HISTORIC LANDMARK COMMISSION FEBRUARY 24, 2020 APPLICATION FOR A HISTORIC SIGN PERMIT C14H-1990-0013 422 GUADALUPE STREET REPUBLIC SQUARE

PROPOSAL

Install two flush-mounted signs.

Building seen from the south, looking across Republic Square.

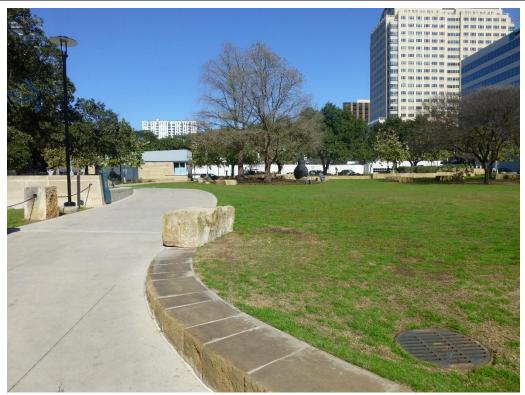
The proposed sign on the south elevation is 29 square feet, while the proposed sign on the east elevation is 37 square feet. Neither meets this standard. However, staff feels that the larger signs may be appropriate given their orientation to the large open spaces in Republic Square and the Federal Courthouse plaza.

The ampersand on both signs is proposed to be neon. The Commission may consider this proposal as a limited element on both signs.

The building does not have a business entrance; instead, the proposed signs are located above the order windows.

Approve the proposed sign design and dimensions, and consider the exposed neon ampersands.
